LOCA at 11th and Belmont The Goat Blocks

Design Review Submittal (LU# 14-125908 DZM AD) (DAR# 13-224797) (Pre-Application# EA-203772)

PRESENTED BY: KILLIAN PACIFIC
OWNER: BELMONT INVESTMENT, LLC
ARCHITECT: ANKROM MOISAN ARCHITECTS
08.12.2014

South Building: Goal after DR Hearing #2

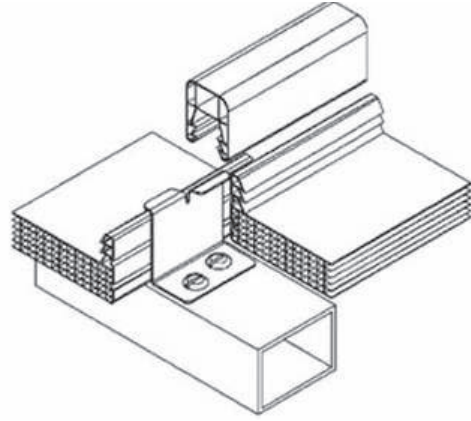
- Better describe Garden Center/Nursery roof design, by providing physical sample for BDS Staff and DR Commission review

East Building: Design Goals after DR 2

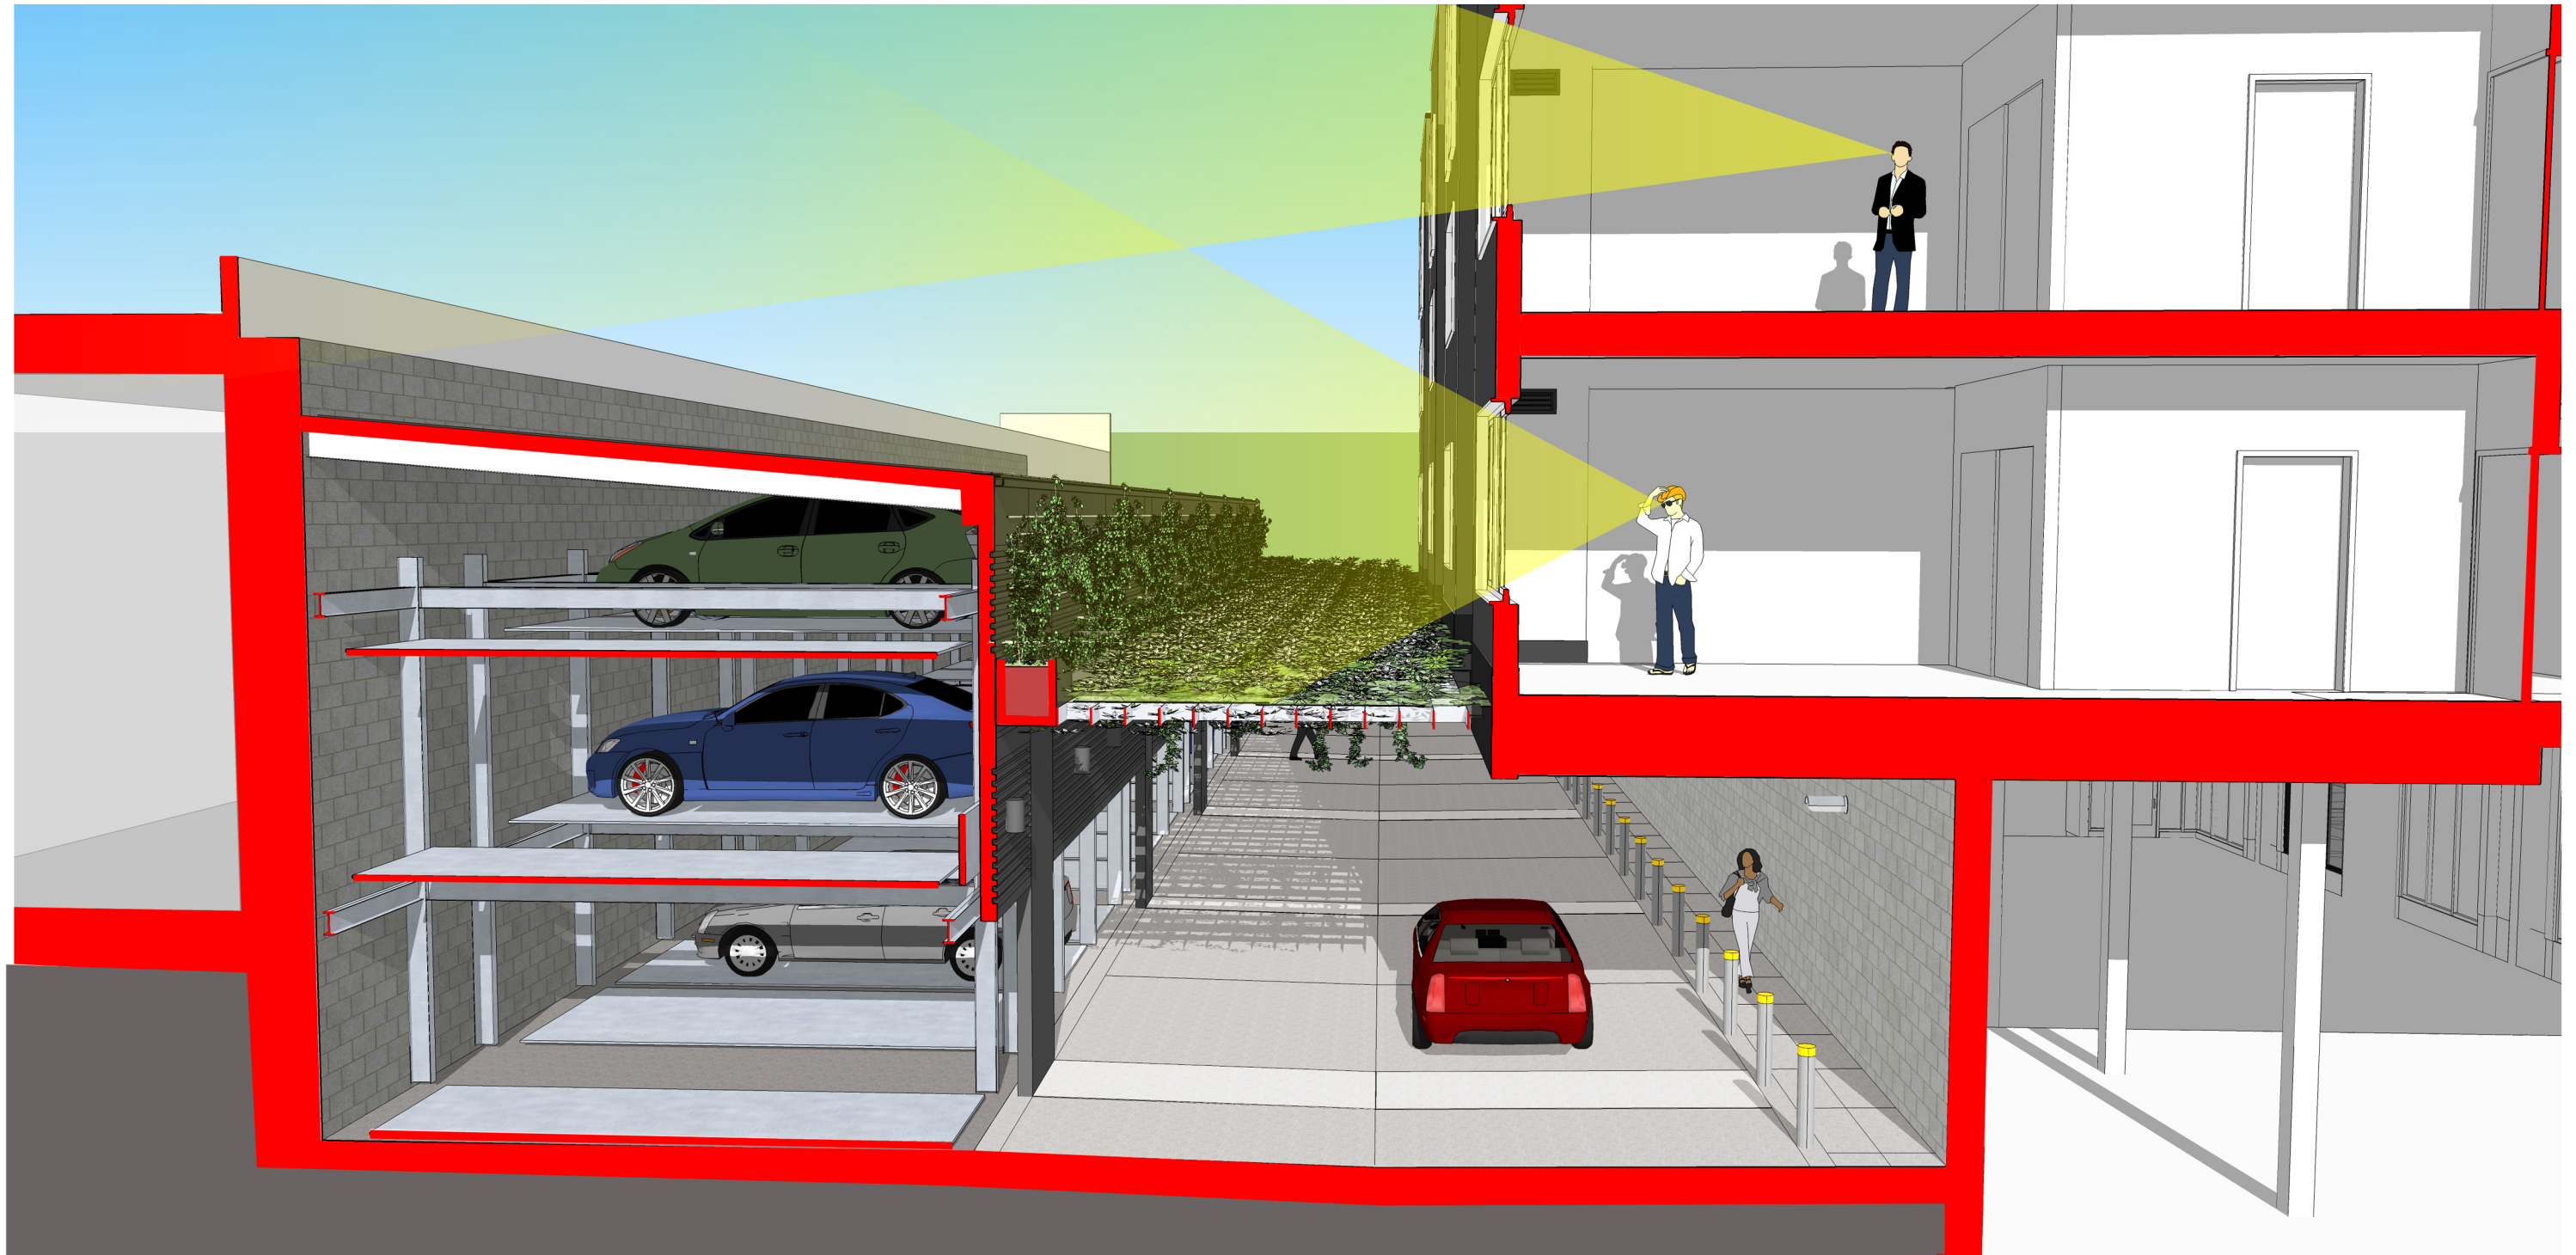
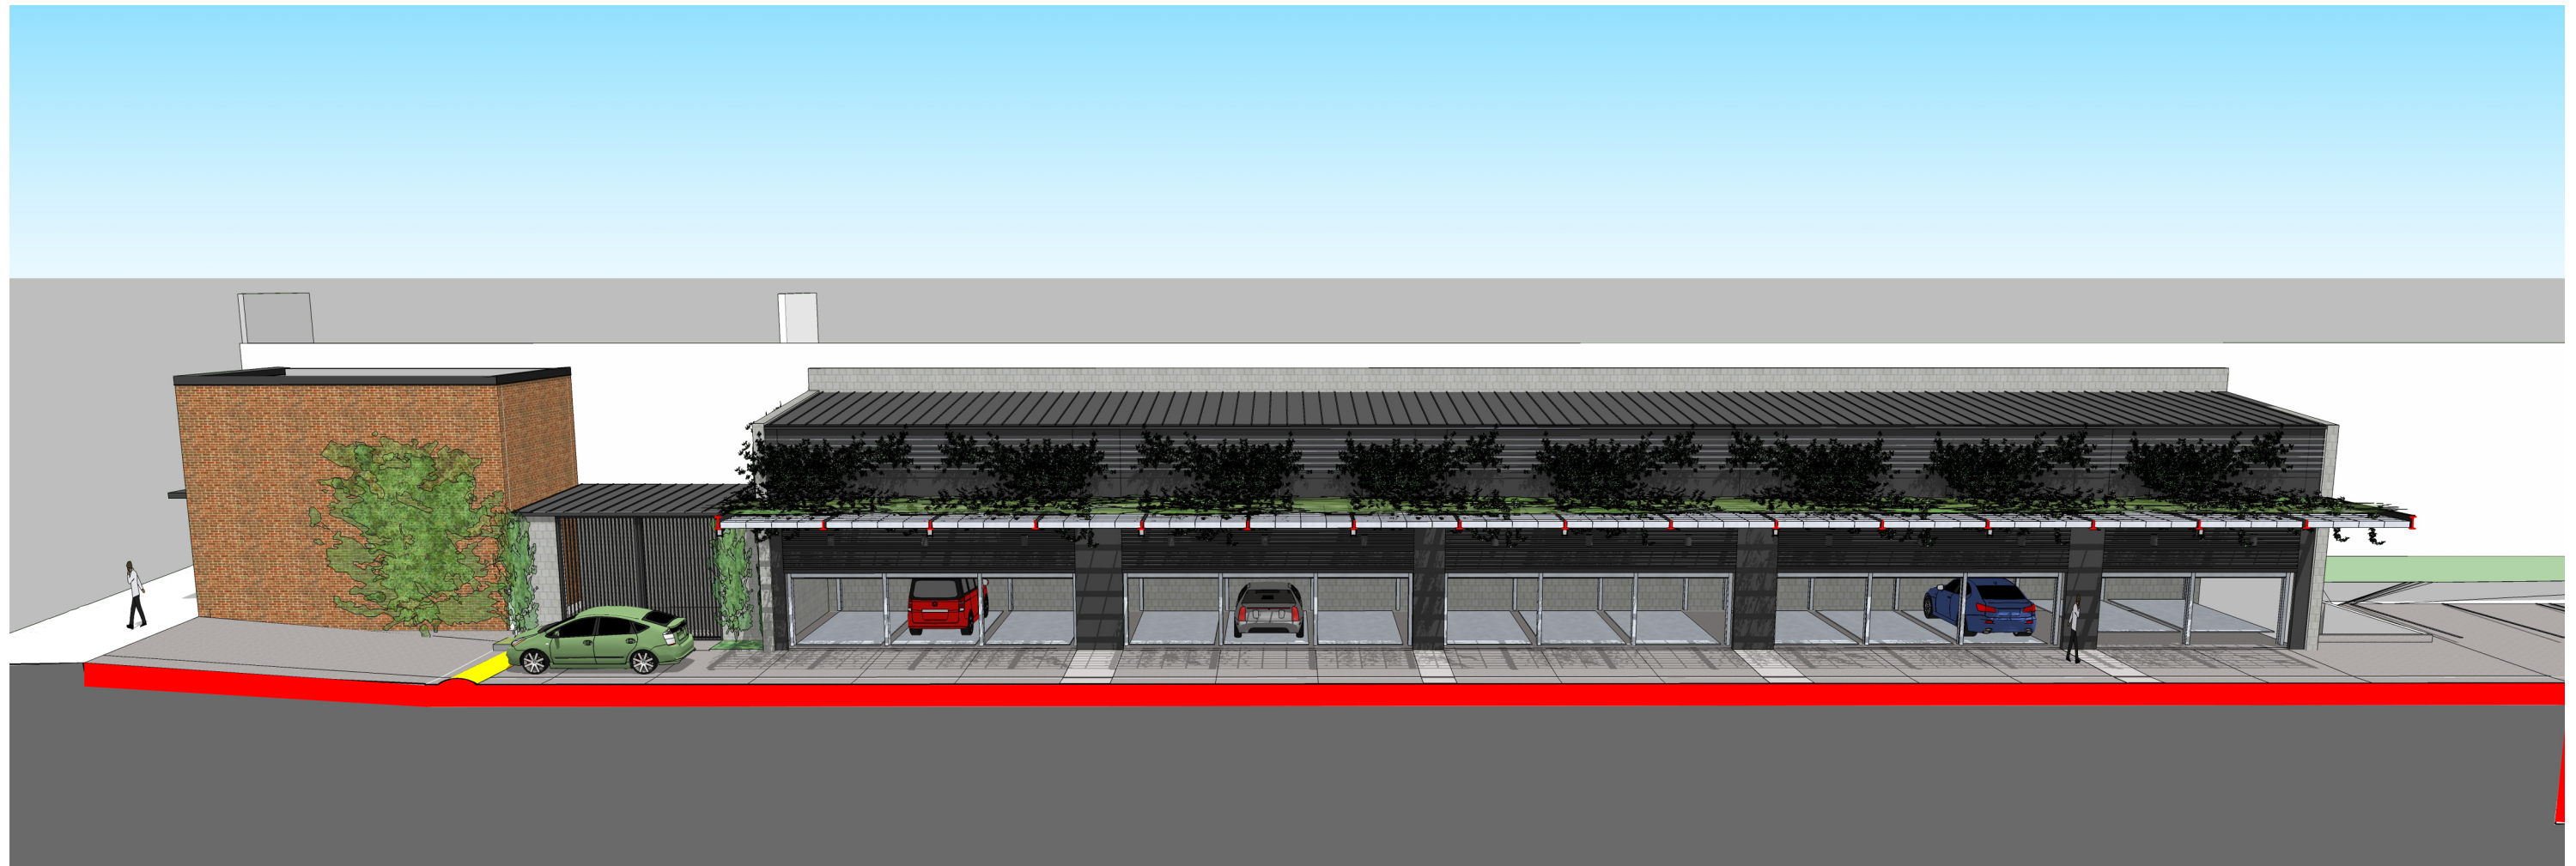
- Simplify and enhance design of base further, by removing natural wood siding
- Screen views from east facing units, towards mechanical parking
- Enhance clarity of walking vs. auto uses in parking area, to better protect pedestrian traffic
- Enhance Mechanical Parking Enclosure design
- Enhance overall design friendliness while maintaining clarity of design purpose.
